**BEFORE INDEPENDENT COMMISSIONERS APPOINTED
BY THE QUEENSTOWN LAKES DISTRICT COUNCIL**

IN THE MATTER of a submission by Gertrude's Saddlery Limited and Larchmont Developments Limited seeking rezoning of land at 111 and 163 Atley Road from Rural to both Lower Density Suburban Residential and Large Lot Residential

STATEMENT OF EVIDENCE OF ARTHURS POINT COMMUNITY ASSOCIATION

Dated 26 January 2023

Figure 1: Excerpt Taken from Atley Road Roding Overview presented in Mr evidence. Annotated to show the 'Moa' Track

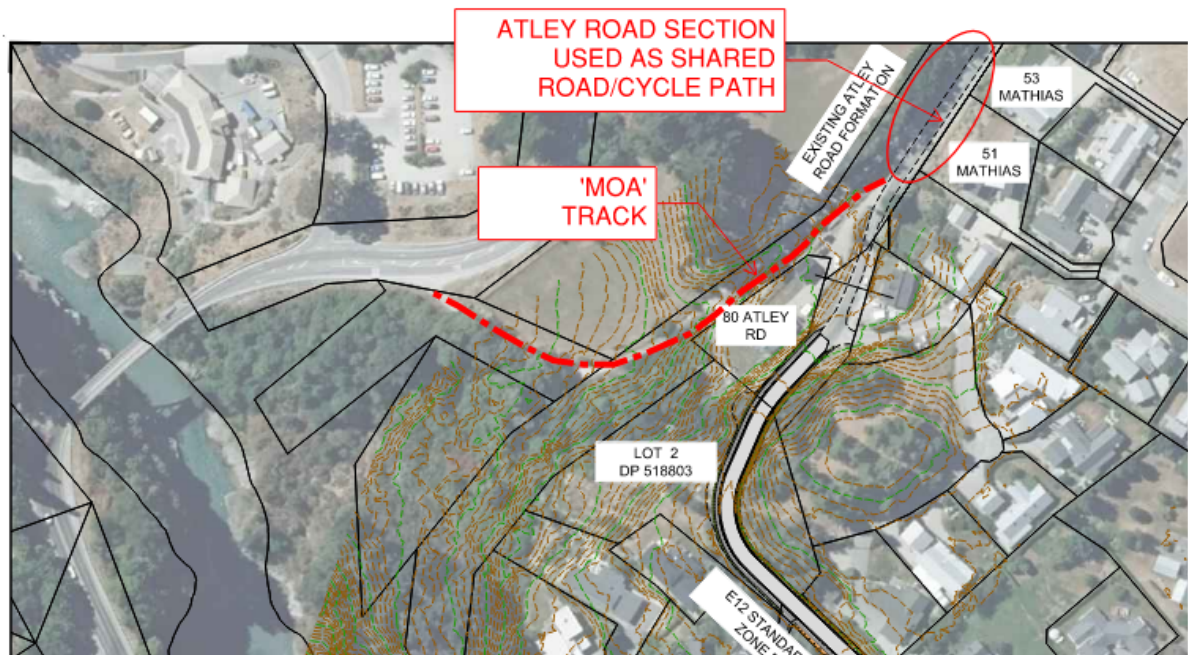
8. Atley Road, from Amber Close (roundabout) to what is colloquially referred to as the Moa Track (shown in Figure 1), is the key and only link to convey pedestrians and cyclists from the north side of the river to the south side of the Shotover River, without having to travel on Arthur's Point Road (Edith Cavell Bridge excepted).

12. With the knowledge that future recreation and commuter trails have to use Atley Road and that the majority of the active transport (AT) route from Arthurs Point to Queenstown is to be upgraded imminently the following key questions need to be answered.

- a. Why is the possible access road design provided by Mr Bartlett, which includes “appropriate transport infrastructure”, inconsistent with proposed upgrades on the remainder of the AT route from Arthurs Point to Queenstown (1.5m footpath vs 2.5m footpath).
- b. Can the section of Atley Road be upgraded to accommodate both the necessary increases in carriageway width to support rezoning and shared cycle/pedestrian width to cater for the upgraded AT route. Noting that the western side of the road is bounded by a circa one metre high retaining wall and a steep ~ 45 degree slope (Figure 2) into the neighbouring property.
- c.

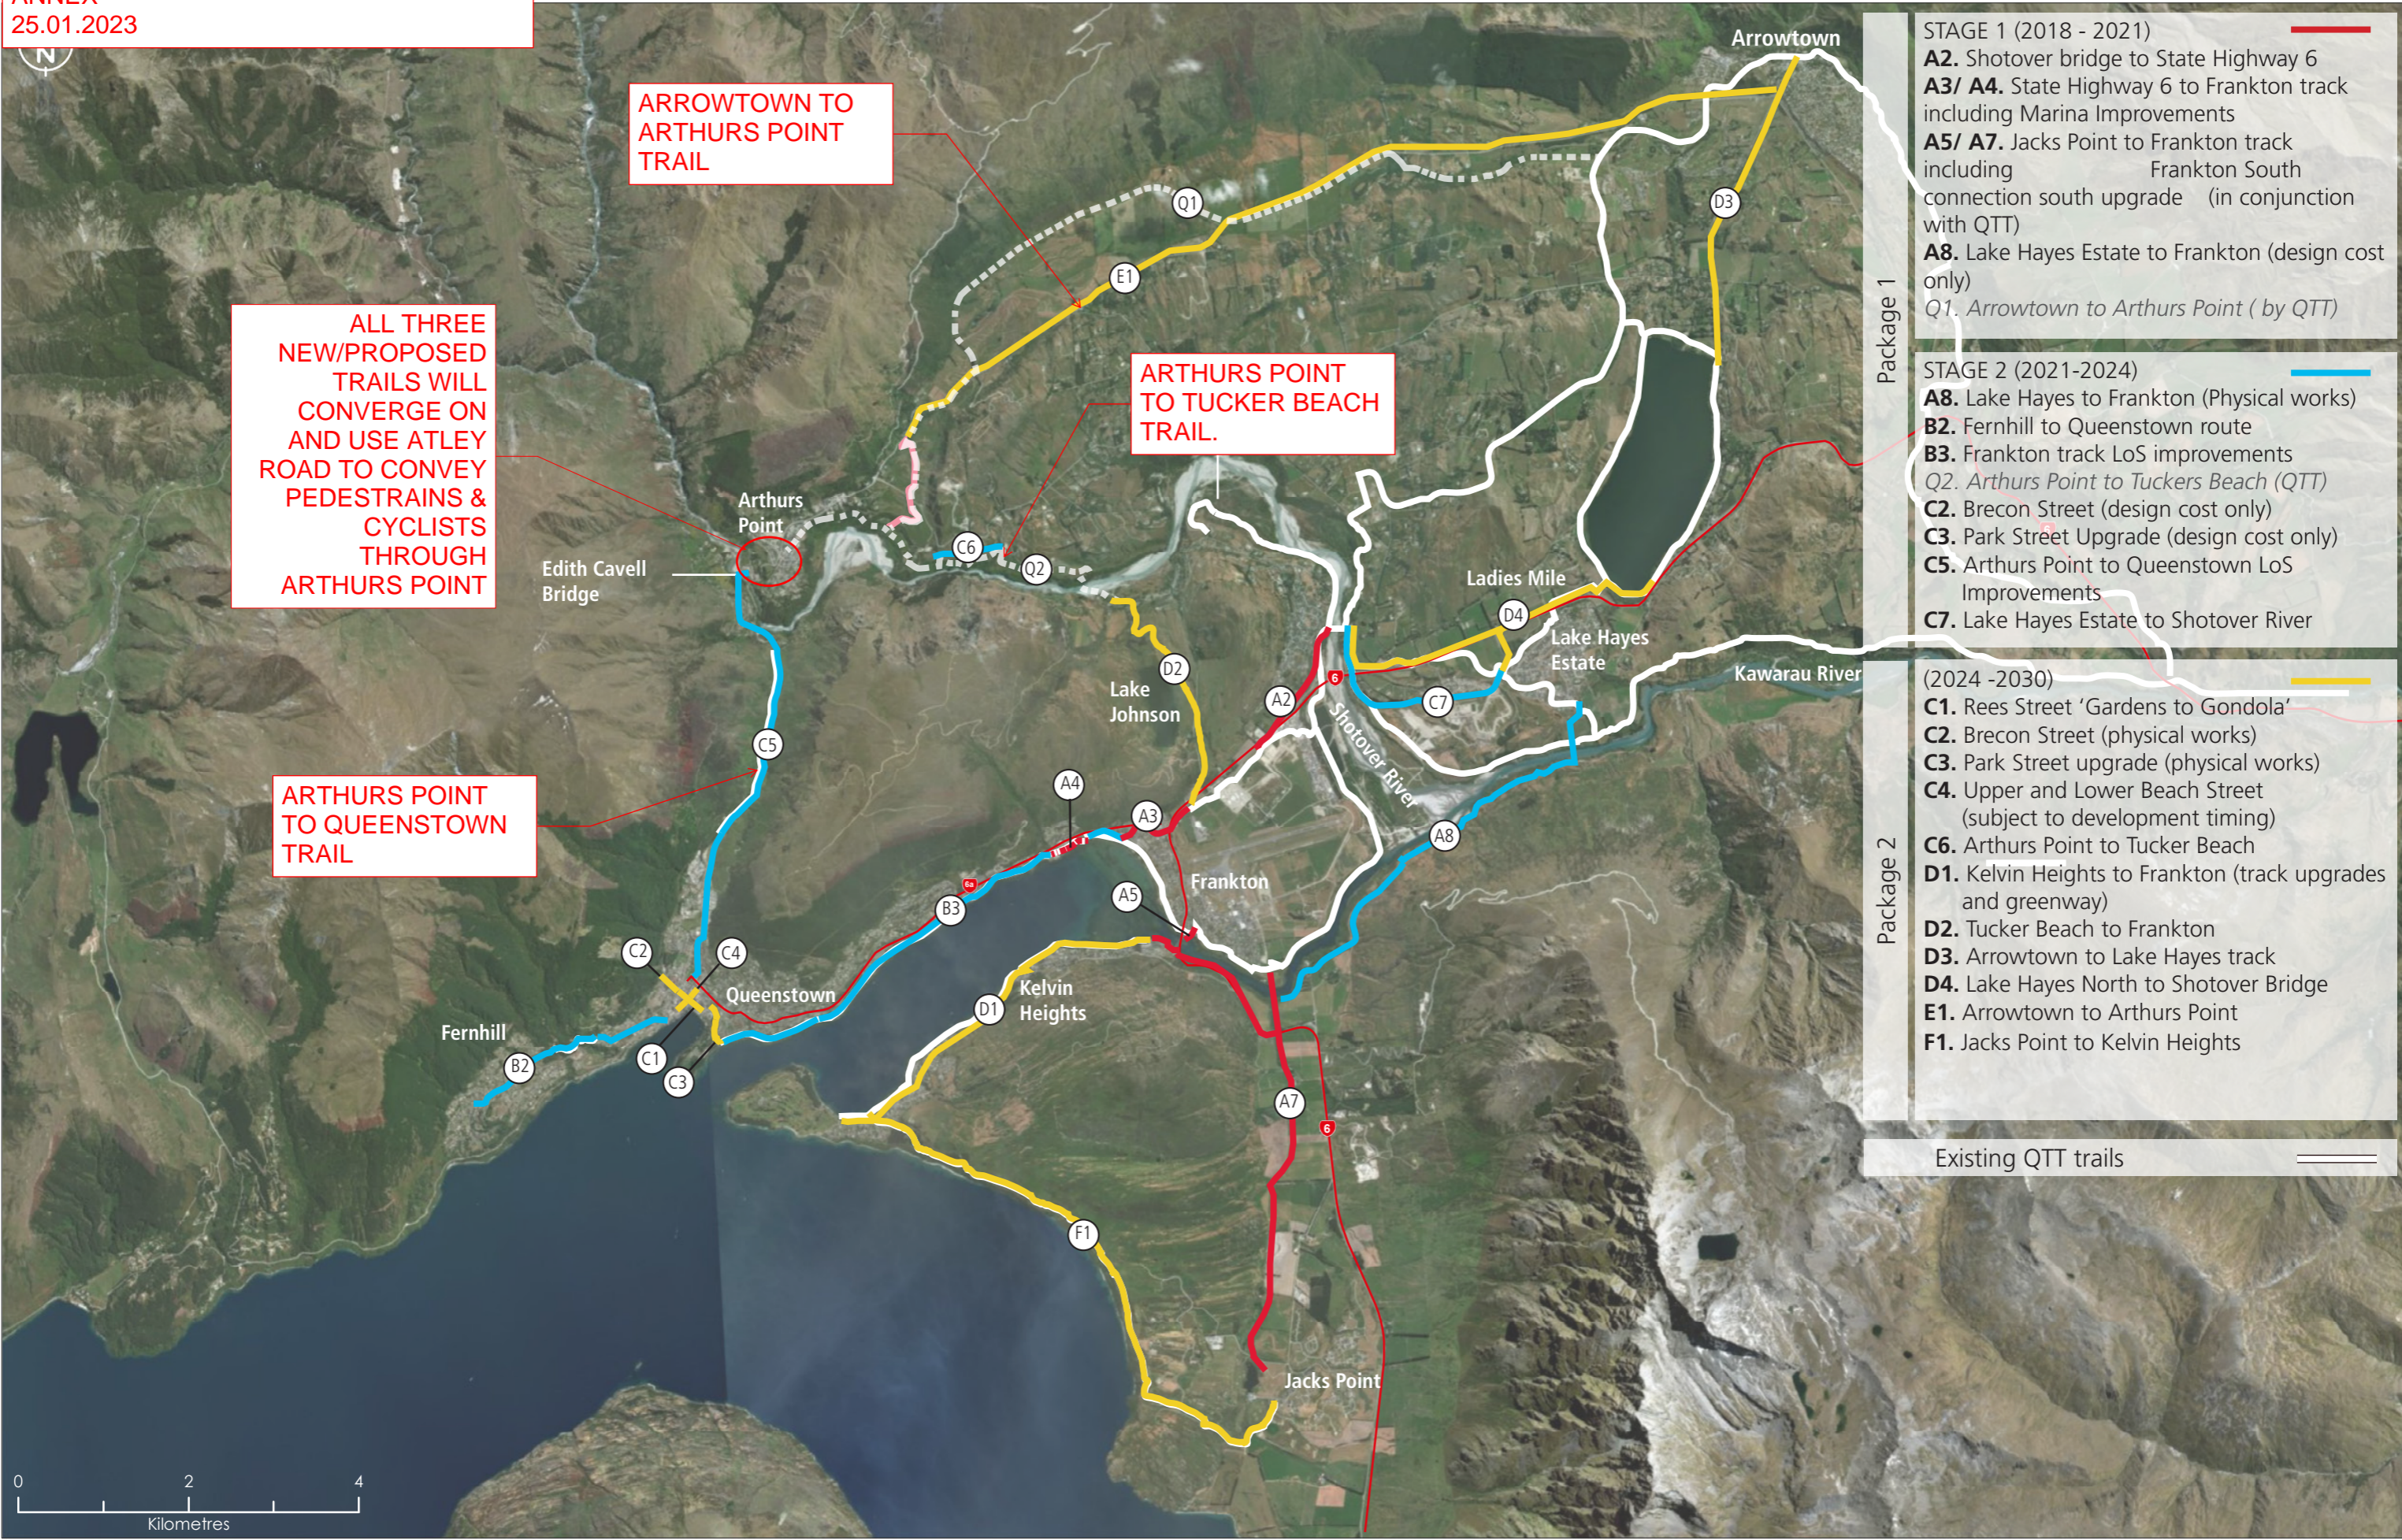
- b. While we acknowledge that the current structure plan provides for access from the site to the conservation land bordering the river, it is limited. The future [Shotover River pedestrian bridge](#) is likely to be located to the western end of the site (or further upstream) and as such access to conservation land bordering the river would be better suited with multiple access points – refer Annex 2 for suggested locations. Similarly, there is an existing QLDC reserve on the north-eastern end of the site that could be (better) connected via access over the site.

ALL THREE
 NEW/PROPOSED
 TRAILS WILL
 CONVERGE ON
 AND USE ATLEY
 ROAD TO CONVEY
 PEDESTRIANS &
 CYCLISTS
 THROUGH
 ARTHURS POINT

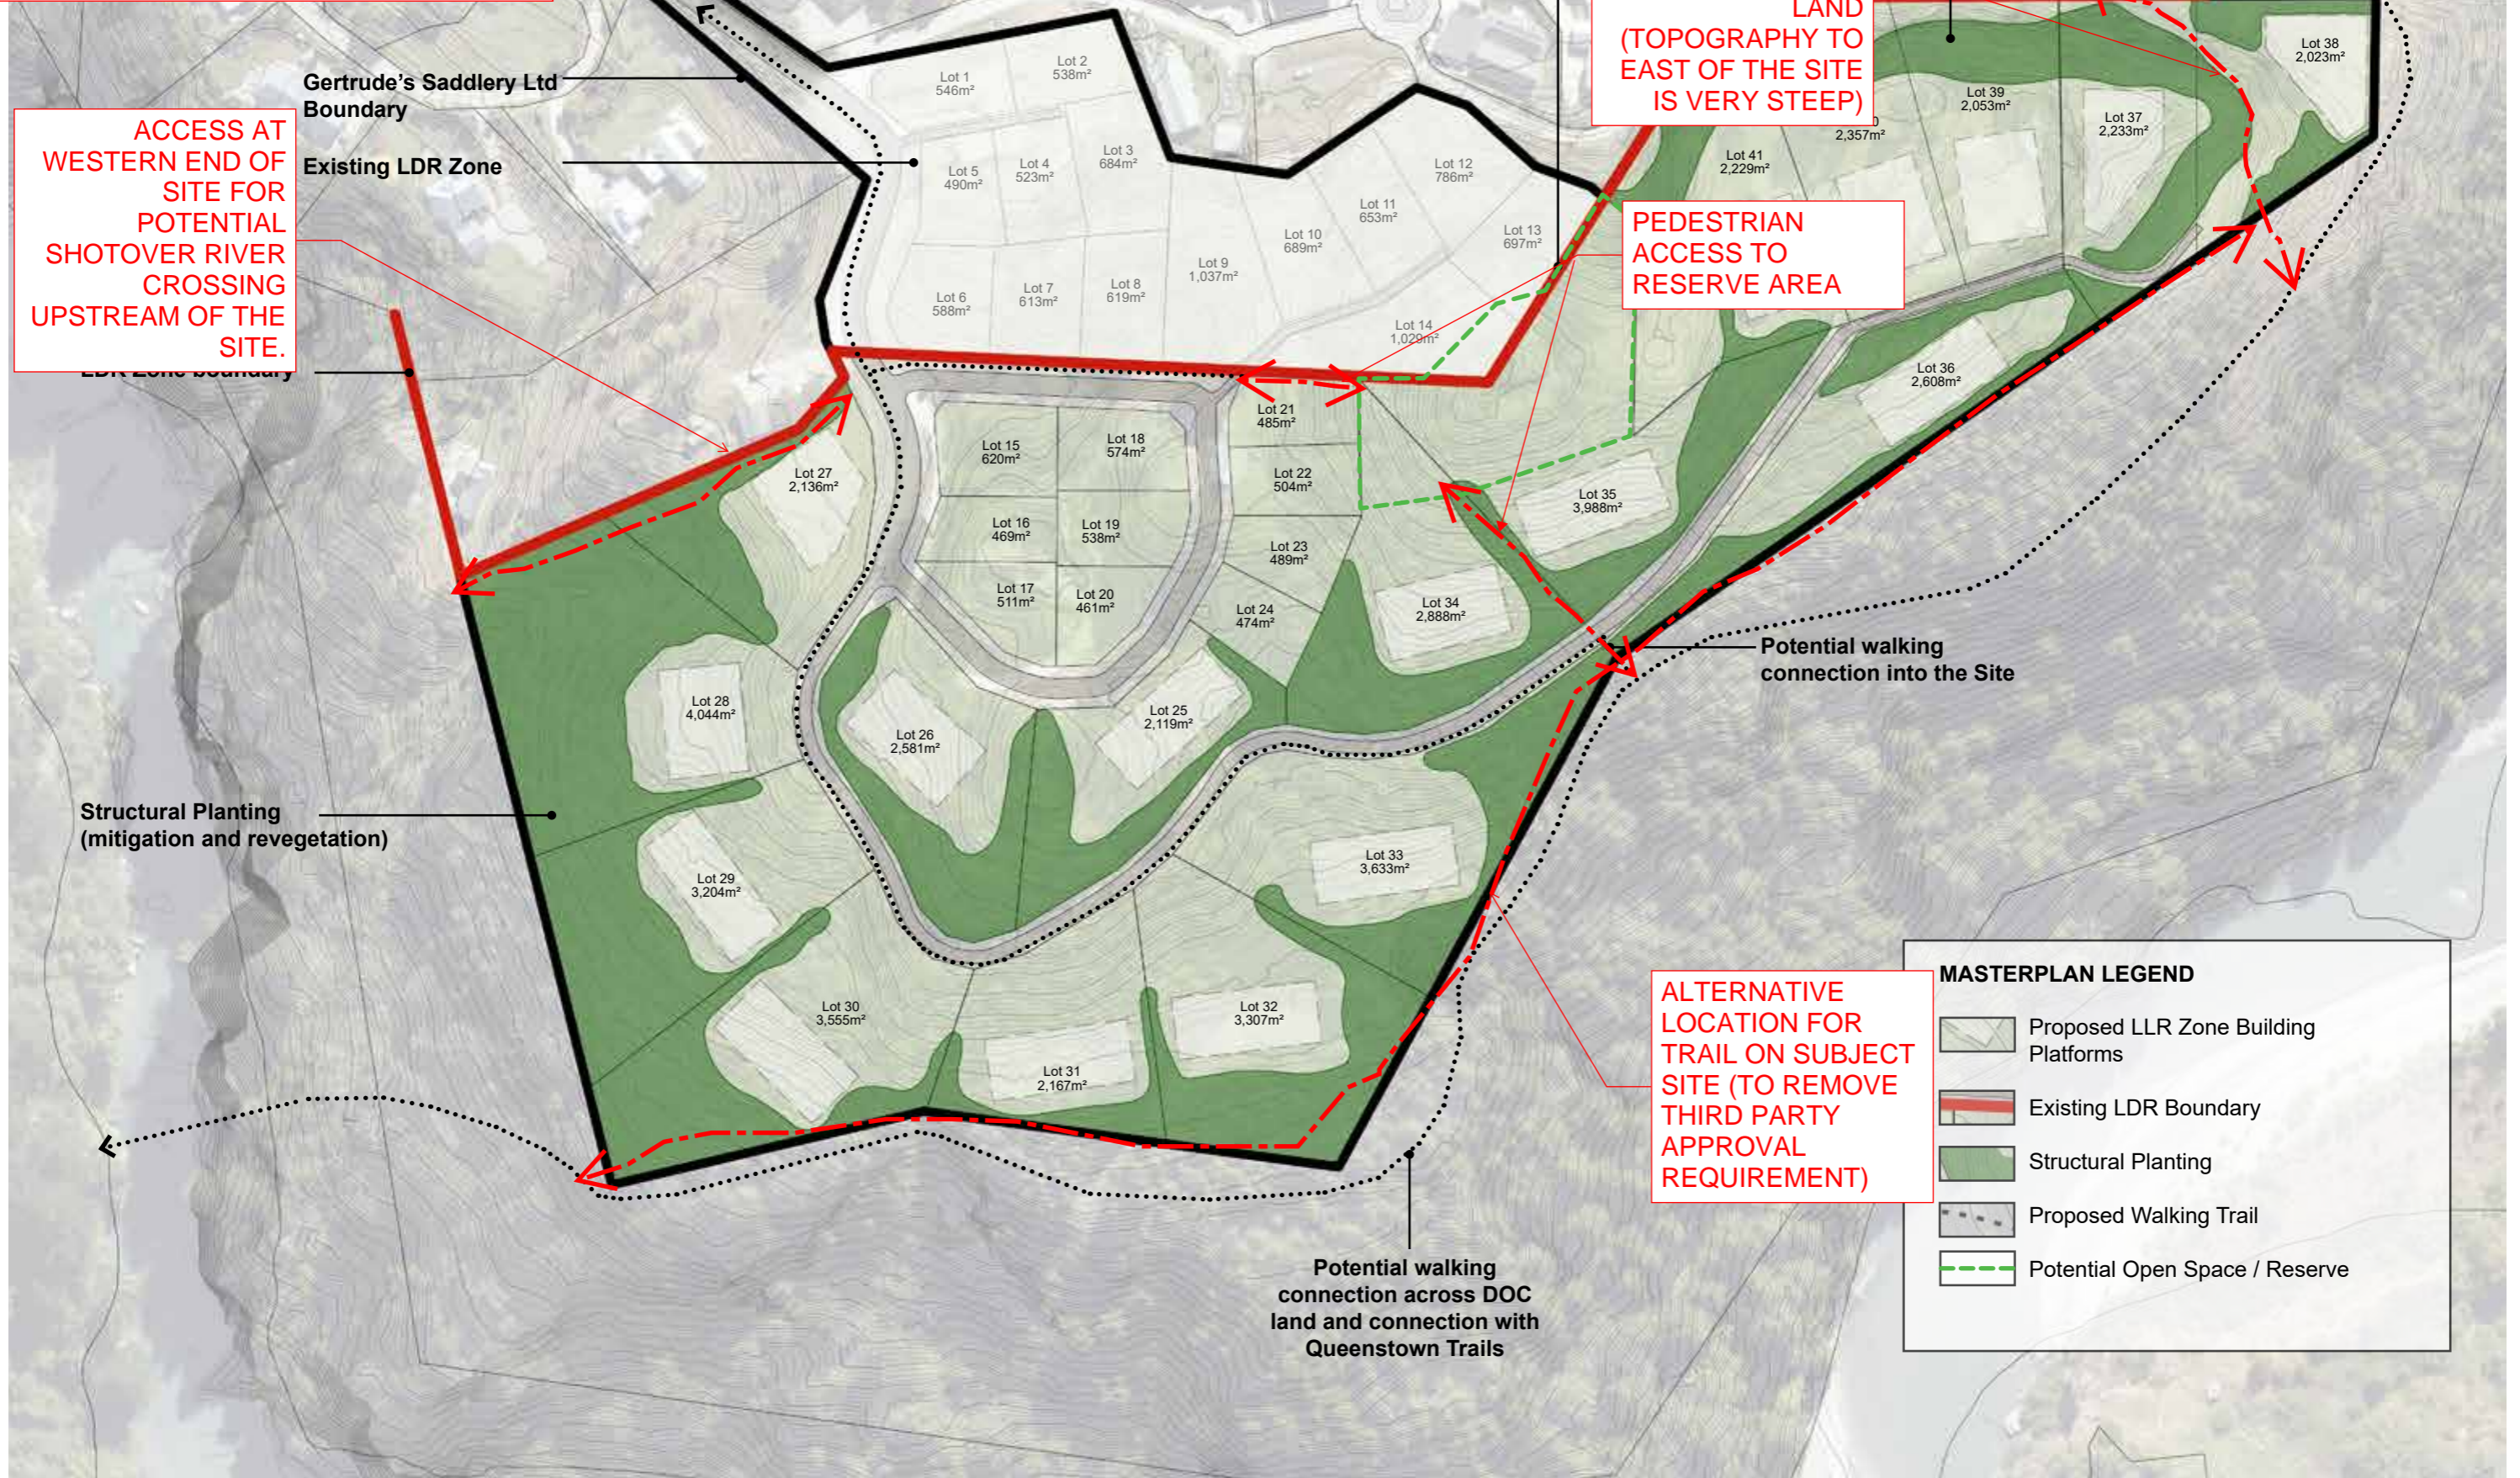
10. The significance of this residential street will grow exponentially in the coming years as the Queenstown Trails Trust - Arthurs Point to Arrowtown and Arthurs Point to Tucker Beach trails come on line (refer Annex 1) and will funnel an increasing number of cyclists/pedestrians, including people from outside of Arthur's Point, onto Atley Road as they cycle, run or walk to/from Queenstown for recreation or transport.
